project
PROPOSED ALTERATIONS AND REAR EXTENSION AT THE SPITKO GREEK RESTAURANT TO INCREASE THE EXISTING RESTAURANT SEATING SPACE ON THE GROUND FLOOR AND WITH FURTHER SEATING SPACE ON THE FIRST FLOOR, INCLUDING A NEW LARGER KITCHEN GROUND FLOOR, NEW TOILETS FIRST FLOOR, AND THE FORMATION OF A FURTHER WINDOW TO THE FRONT ELEVATION
at
No. 6 PROSPECT STREET, CAVERSHAM RG4 8JG
for
MRS. ALKETA KARAJ (owner)
drawing
PLANS AND ELEVATIONS EXISTING AND PROPOSED AND SITE PLAN
date 18/11/2023 scale 1:100
DRAWING NUMBER SR / PL / 02 A

PROPOSED FIRST FLOOR PLAN

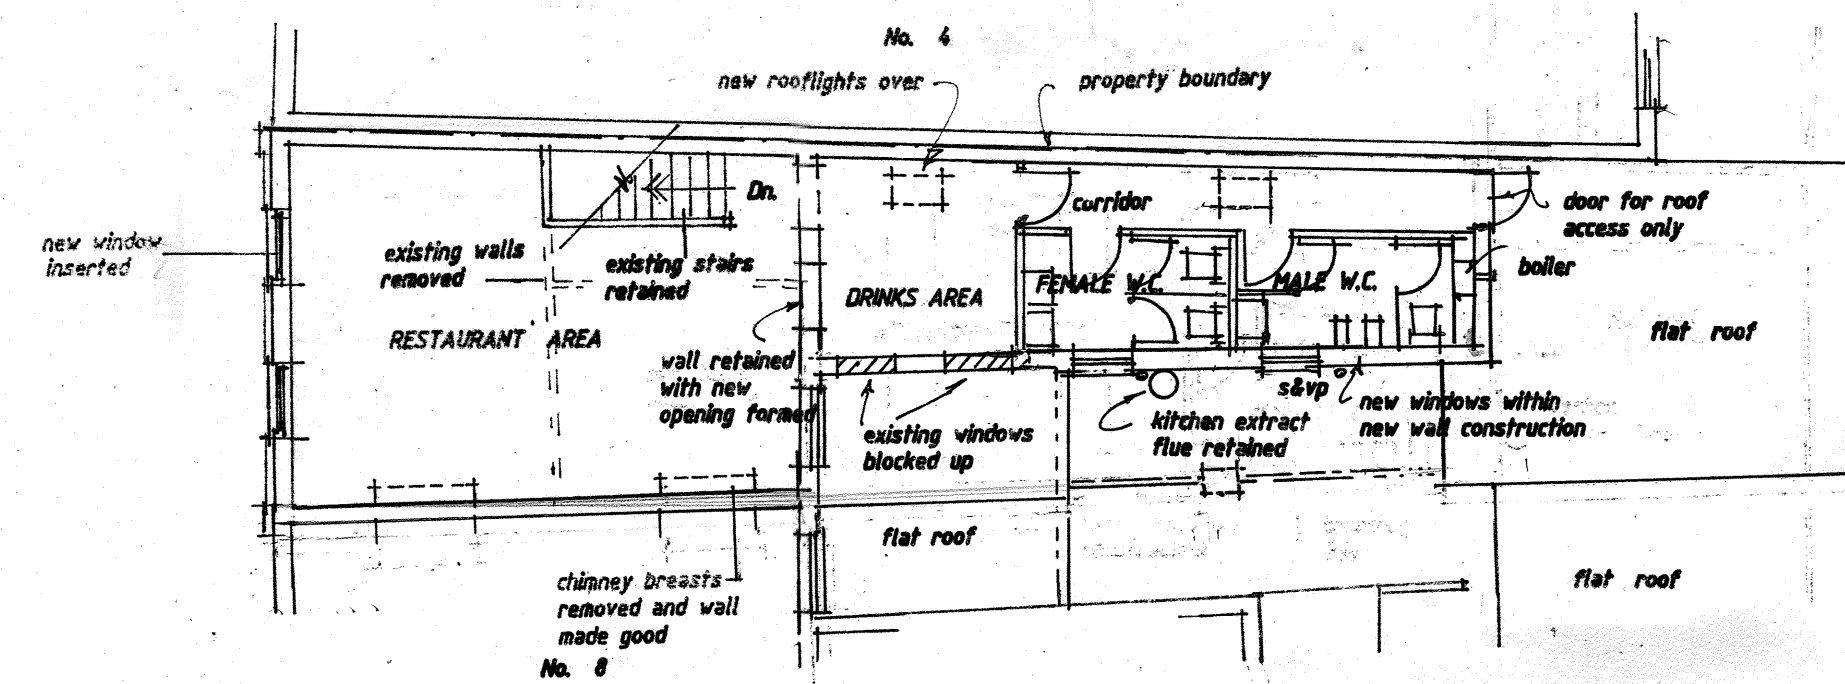
REVISIONS
A Original plans revised to enlarge the kitchen area on the ground floor and the toilet facilities first floor but retaining the open yard to maintain the outlook from the first floor neighbouring window at No 8
16/05/2024
